LEARNING RESOURCES CENTER
BUILDING 'D' AND 'CR' REMODEL

VENTURA COLLEGE

September 24, 2001
KBZ Job No. 93-18

INSPECTOR COPY

DRAWN: L.J.L.
CHECKED: J.T.
DATE: SEPTEMBER 24, 2001
JOB NO.: 93188
SHEET TITLE: INTERIOR DETAILS
SHEET: A-541

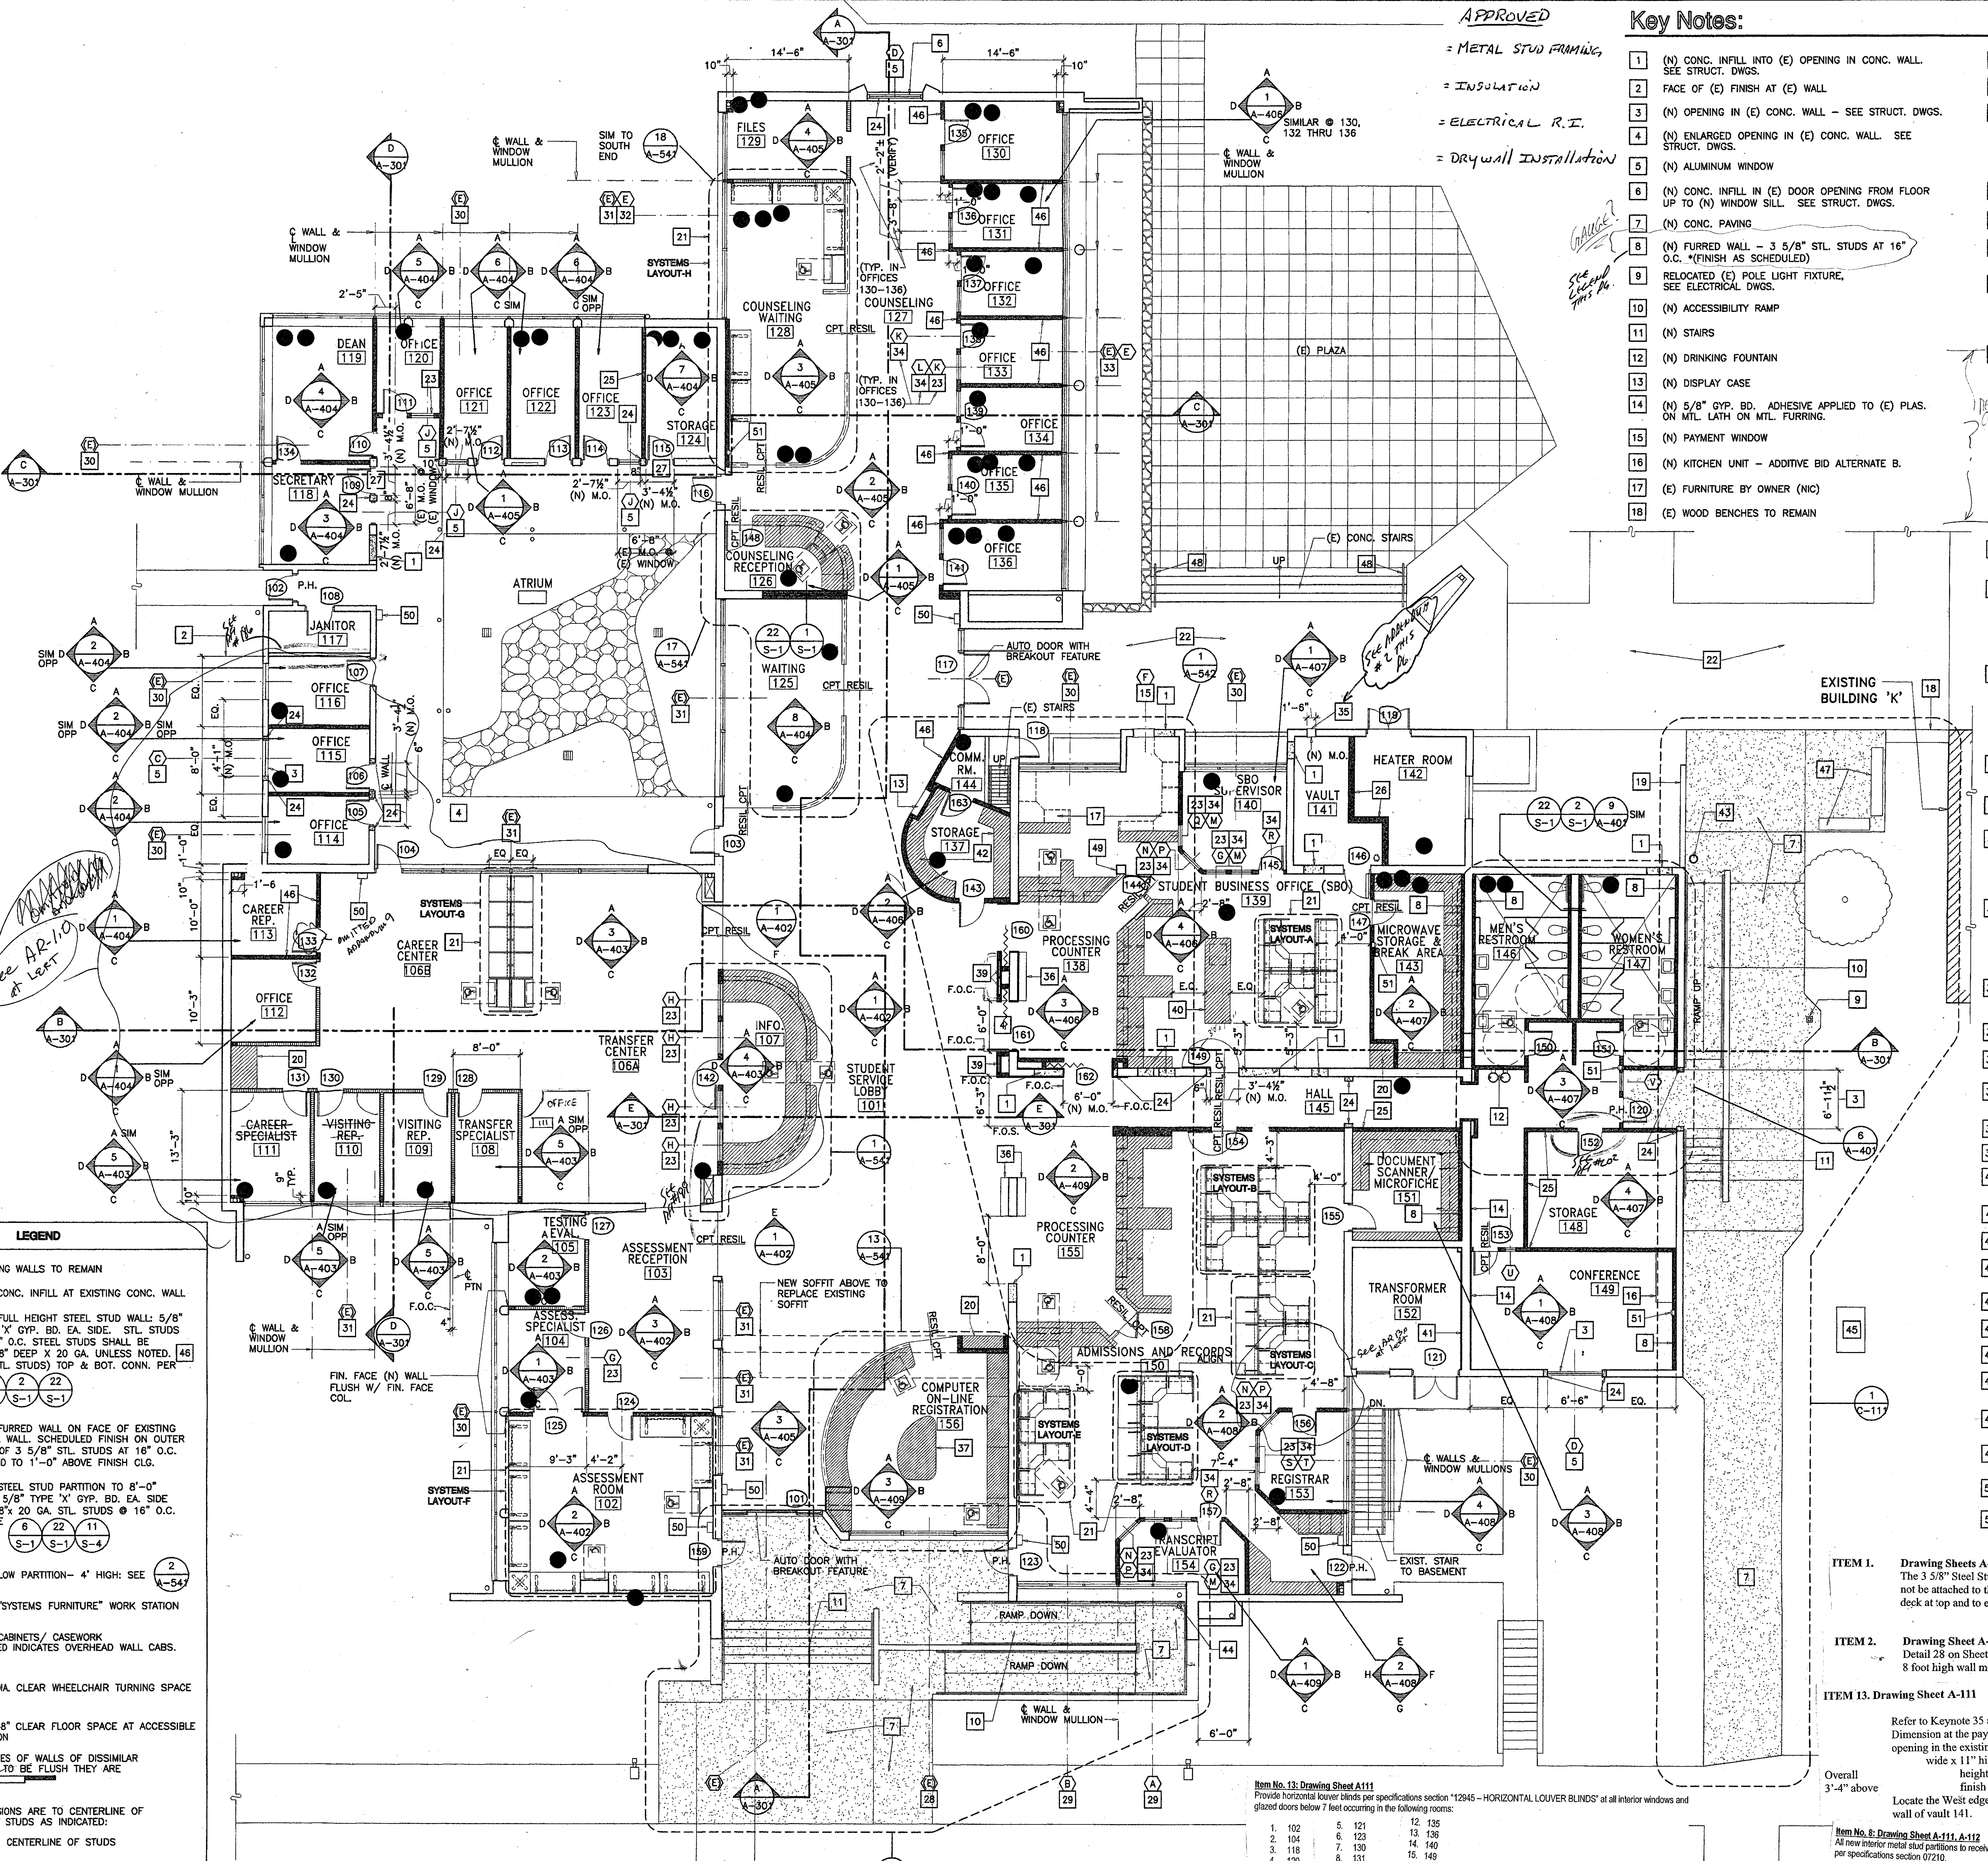
- (E) CONC. WALL
 - SEALANT Drawing Sheets A-541 and A-542. Appendix Z At Keynote 27 revise detail reference to be 13 on Sheet S-4.
 - CONT. SHAPED WOOD NAILER - 3/8" EXPANSION BOLT CTSK @ 18" O.C. EXP. BOLT PER 12 A541

DRAWN	MV/LJL
CHECKED	JT
DATE	SEPTEMBER 24, 2001
JOB NO.	9318B
SHEET TITLE	FIRST FLOOR PLAN BUILDING 'D' REMODEL

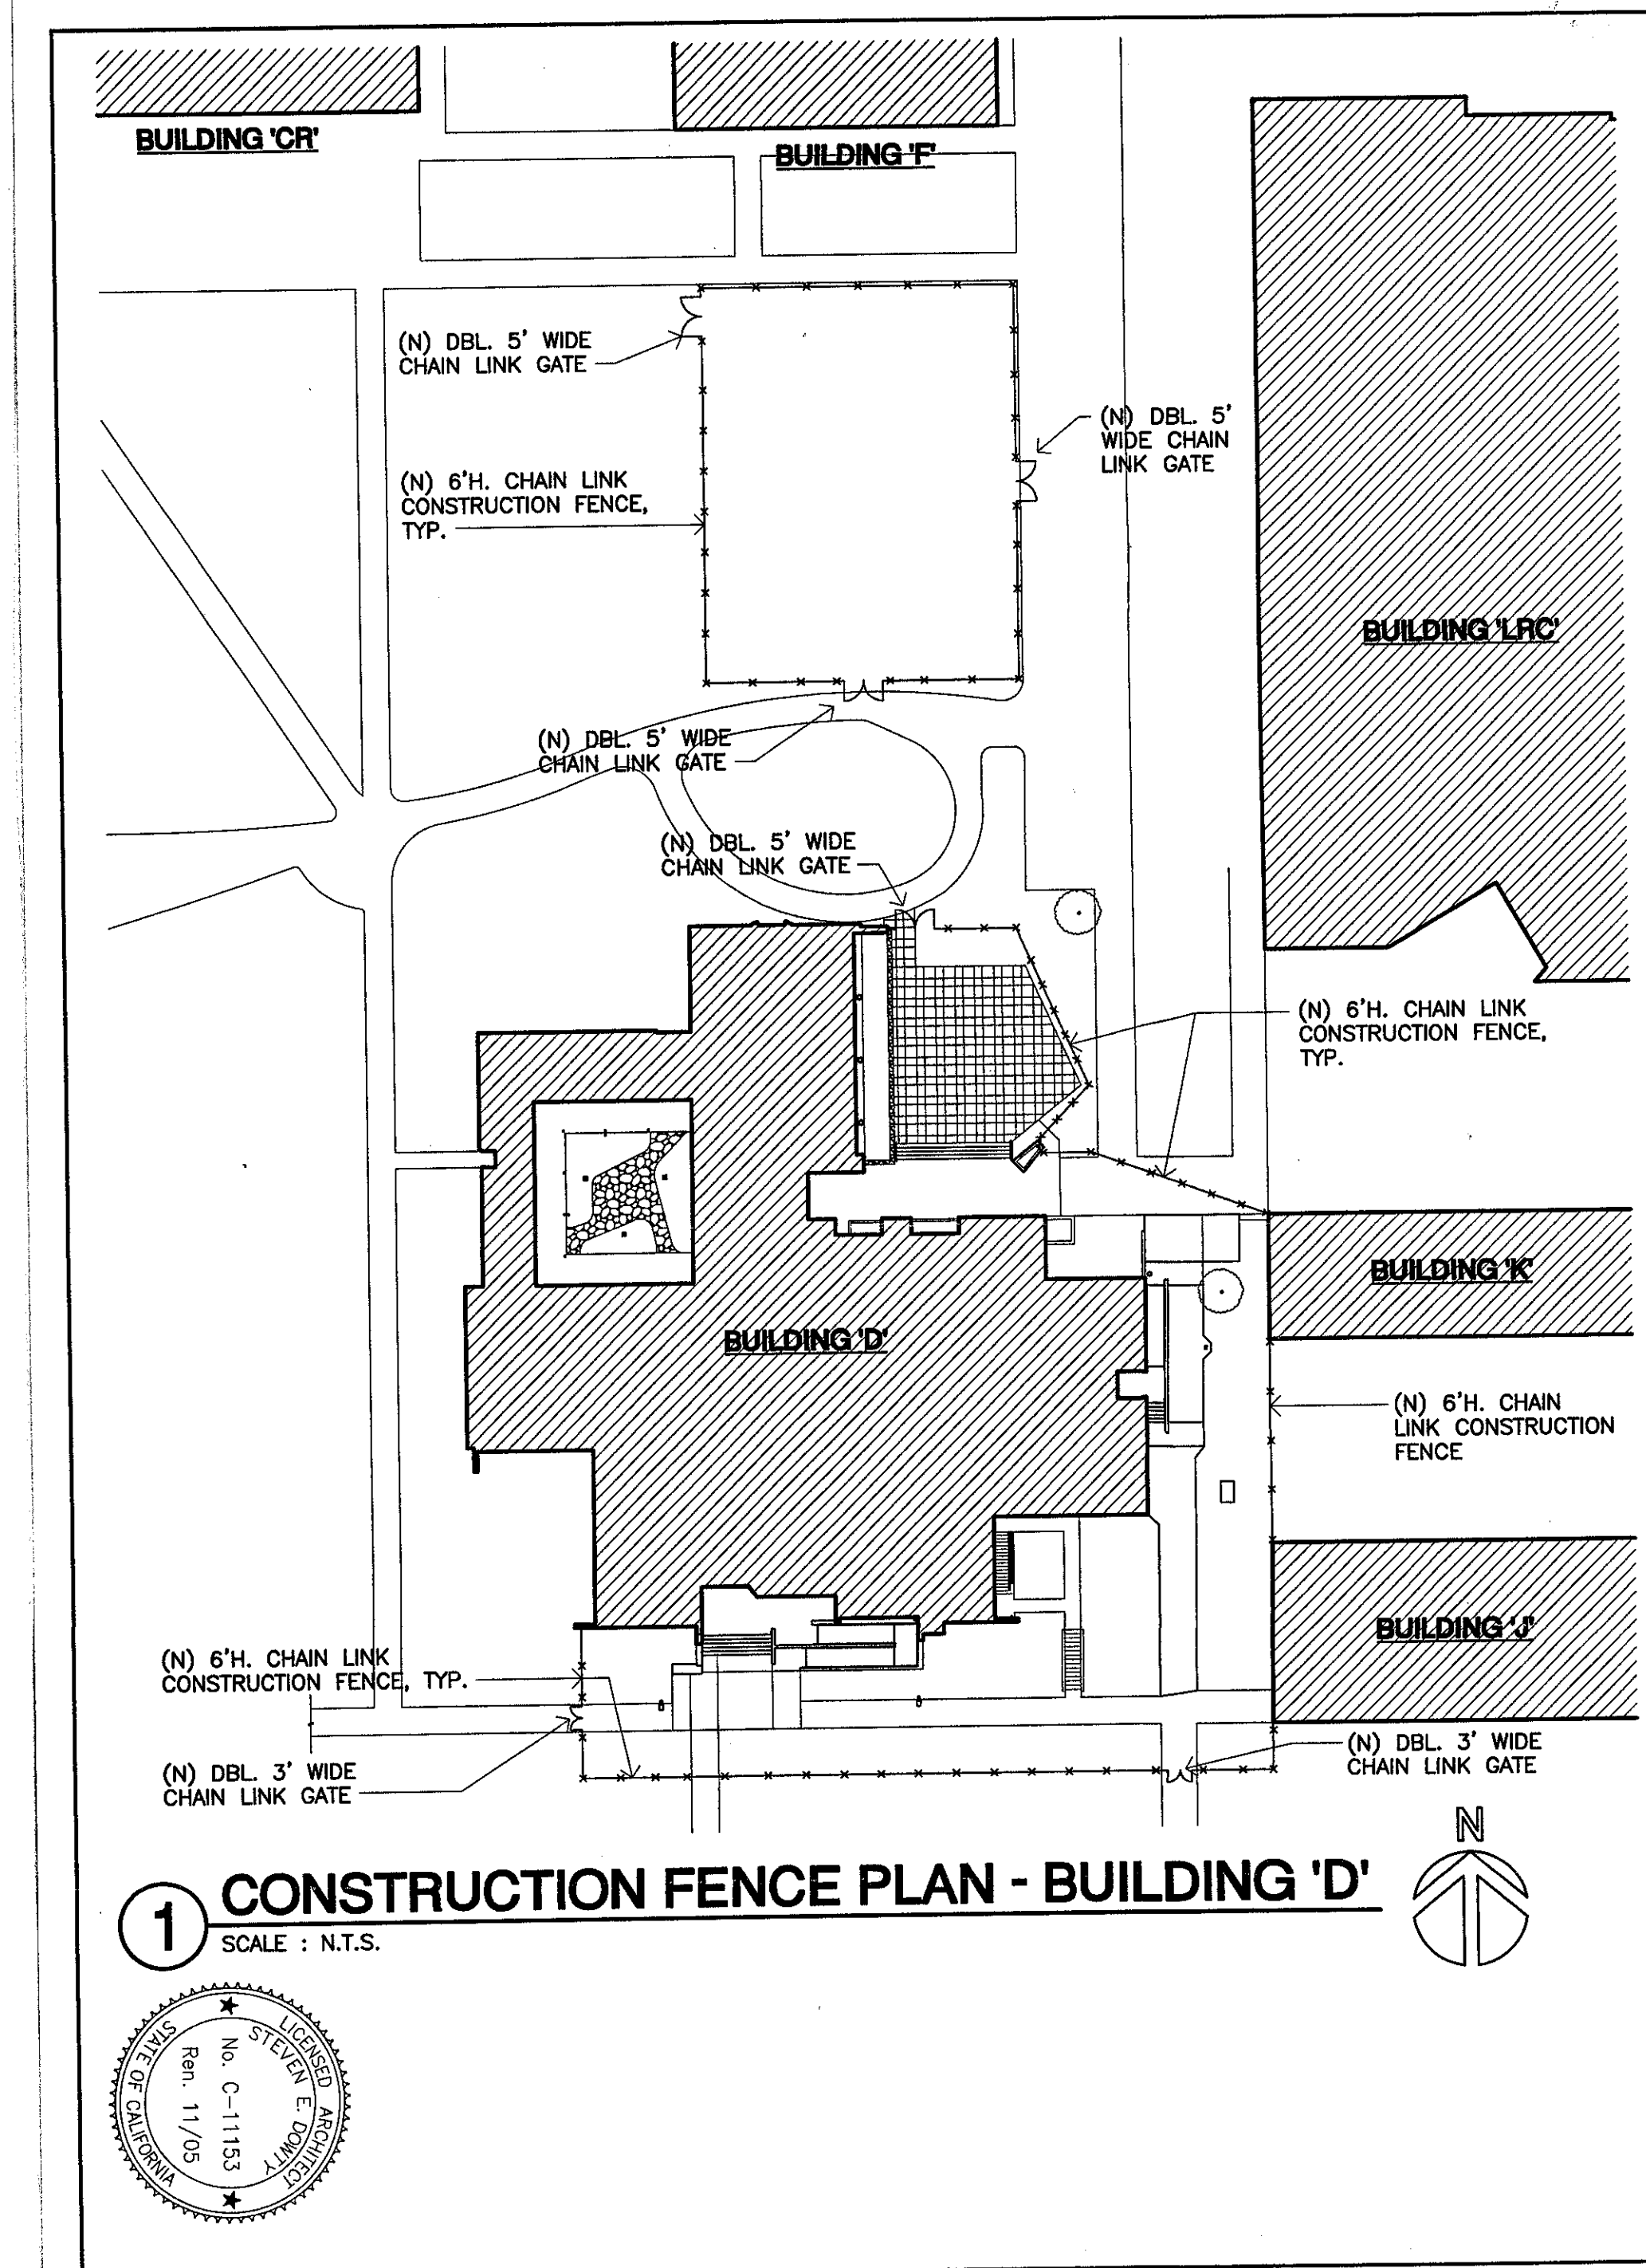
Item No. 13: Drawing Sheet A-111
 Provide horizontal louver blinds per specifications section 12945 - HORIZONTAL LOUVER BLINDS at all interior windows and glazed doors below 7 feet occurring in the following rooms:

- ITEM 1. Drawing Sheets A-111 and A-401 APPENDUM 2**
 The 3 5/8" Steel Stud new furred wall at west wall of Men's Restroom 146 shall not be attached to the existing concrete wall. Attach wall to existing steel roof deck at top and to existing concrete floor slab at bottom.

- ITEM 2. Drawing Sheet A-111 and A-512 APPENDUM 2**
 Detail 28 on Sheet A-512 applies at all conditions where a new full height wall or 8 foot high wall meets into a new or existing window mullion.

- ITEM 13. Drawing Sheet A-111 APPENDUM 2**
 Refer to Keynote 35 and the North wall of Vault 141. Delete the 1'-6" width Dimension at the payment depository. The Dimensions of the new sawcut opening in the existing concrete wall for the new payment depository are: 1'-2 1/2" wide x 11" high subject to verification by depository manufacturer. height of opening as required to locate pull handle of depository at finish paving surface at depository. Locate the West edge of depository opening 1'-6" from the inside face of the west-wall of vault 141.
